Access Compliance Report

Public Rights-of-Way

Intersection ID: 10029691	Main Street: KINGSLEY_VIEW_DR	Cross Street: N/A	Location: NE
ADA ID: 8DAC9F4E04AC	Ramp Type: PerpDiag	Initial Pass/Fail: Fail	Overall Compliance: No
		Severity Score: 35

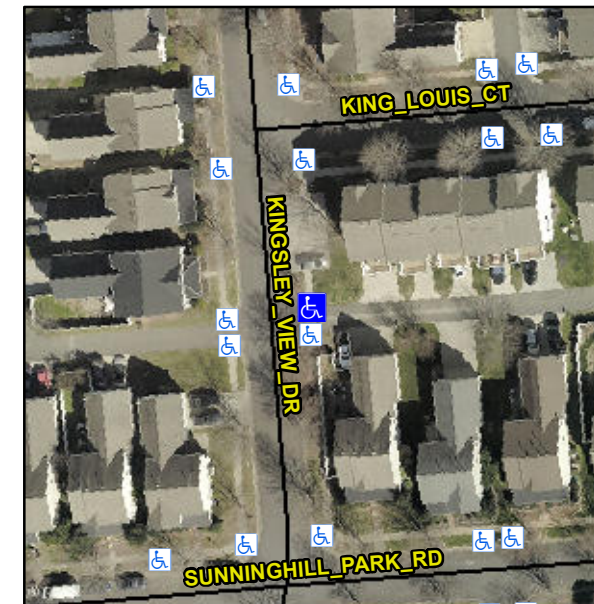
Not Found, R304.5.1, R304.2.2, R304.5.3

Compliance	Description	Data	Compliance	Description	Data
N/A	Ramp Length (in)	180.0	No	Ramp Slope (%)	13.2
No	Ramp Width (in)	45.0	No	Ramp XSlope (%)	4.8
N/A	Flare Type LT	N/A	N/A	Flare Type RT	N/A
N/A	Flare Slope LT (%)	N/A	N/A	Flare Slope RT (%)	N/A
N/A	Flare Traversable LT?	N/A	N/A	Flare Traversable RT?	N/A
N/A	Landing Length (in)	N/A	N/A	DWS Provided?	N/A
N/A	Landing Width (in)	N/A	N/A	DWS Contrast?	N/A
N/A	Landing Slope (%)	N/A	N/A	DWS Length (in)	N/A
N/A	Landing X Slope (%)	N/A	N/A	DWS Full Width?	N/A
N/A	Landing Curb? (Y/N)	N/A	N/A	DWS Offset (in)	N/A
N/A	Shared Landing?	N/A			
N/A	Gutter Ponding?	N/A	N/A	Gutter Slope (%)	N/A
N/A	Gutter Lip Ht (in)	N/A	N/A	Gutter X Slope (%)	N/A
N/A	Painted X Walk1?	No	N/A	Painted X Walk2?	No
	X Walk 1 Direction	To W		X Walk 2 Direction	To S
N/A	X Walk 1 Width (in)	N/A	N/A	X Walk 2 Width (in)	N/A
	X Walk 1 Slope (%)	0.6		X Walk 2 Slope (%)	0.1
	X Walk 1 X Slope (%)	0.9		X Walk 2 X Slope (%)	3.4

Remove & Replace Curb Ramp With Two New Directional Ramps or Equivalent.
